AMD-K6[®]

Processor Revision Guide

Model 7

Publication # 21846 Rev: F Amendment/ 0 Issue Date: June 1998
--

Figure 1. AMD-K6[®] Processor Assertion of HLDA Due to Simultaneous $\overline{\text{BOFF}}$ /HOLD Assertion

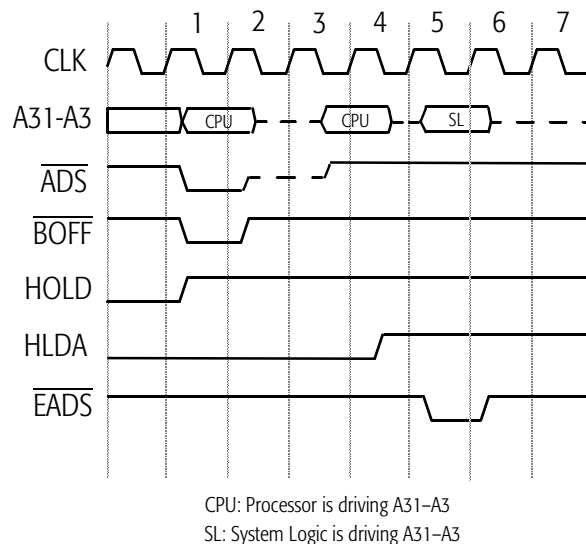
Normal Specified Operation. If $\overline{\text{BOFF}}$ and HOLD are sampled asserted on the same clock edge that negates $\overline{\text{ADS}}$, the processor asserts HLDA one clock edge after HOLD is sampled asserted.

Non-conformance. If $\overline{\text{BOFF}}$ and HOLD are sampled asserted on the same clock edge that negates $\overline{\text{ADS}}$, the processor asserts HLDA two clock edges after HOLD is sampled asserted.

Potential Effect on System. There are three potential effects of this erratum to consider:

- If the system logic asserts $\overline{\text{BOFF}}$ for a duration of one clock, anticipates the assertion of HLDA in clock 3 (see Figure 1)—which is the normal specified operation—and drives the address bus and $\overline{\text{EADS}}$ for an inquire cycle in clock 3, then the processor will not sample $\overline{\text{EADS}}$ asserted. In addition, address bus contention will occur in clock 3.

- If the system logic asserts $\overline{\text{BOFF}}$ for a duration of two clocks, anticipates the assertion of HLDA in clock 3, and drives the address bus and $\overline{\text{EADS}}$ for an inquire cycle in clock 3, then the processor will not sample $\overline{\text{EADS}}$ asserted. (No address bus contention occurs in this case.)

- If the system logic asserts $\overline{\text{BOFF}}$ for a duration of one clock, anticipates the assertion of HLDA in clock 3, and drives the address bus and $\overline{\text{EADS}}$ for an inquire cycle in clock 4, then address bus contention may occur in clock 4. (The processor will sample $\overline{\text{EADS}}$ asserted in this case.)

If the processor does not sample $\overline{\text{EADS}}$ asserted during an inquire cycle, cache/memory incoherency will occur. Address bus contention can affect the reliability of the processor and the system logic.

Suggested Workaround. The system logic must sample the assertion of HLDA before asserting $\overline{\text{EADS}}$ and driving the address bus for an inquire cycle—as shown in clock 5 of Figure 1.
